250x40 SPREADLEVER BRAKE, AUTO-REVERSE

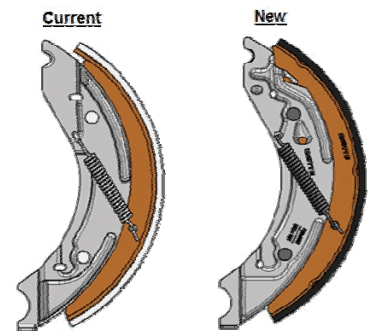
As part of our continual improvement programme the brake shoe and automatic reverse carrier has undergone a design change. This will be a transitional change in order to standardise production on the brake shoe assembly that can be used with or without the automatic adjustment (ANS) option.

- * The **current** complete brake shoe assembly comprises:-
Brake shoe 25375.01 and brake shoe carrier 25137.
- * The **new** complete brake shoe assembly will comprises:-
Brake shoe 411341.001 and brake shoe carrier 411346.001.

The change will not affect fit or function and is fully compatible with existing spreadlever brakes and backplates.
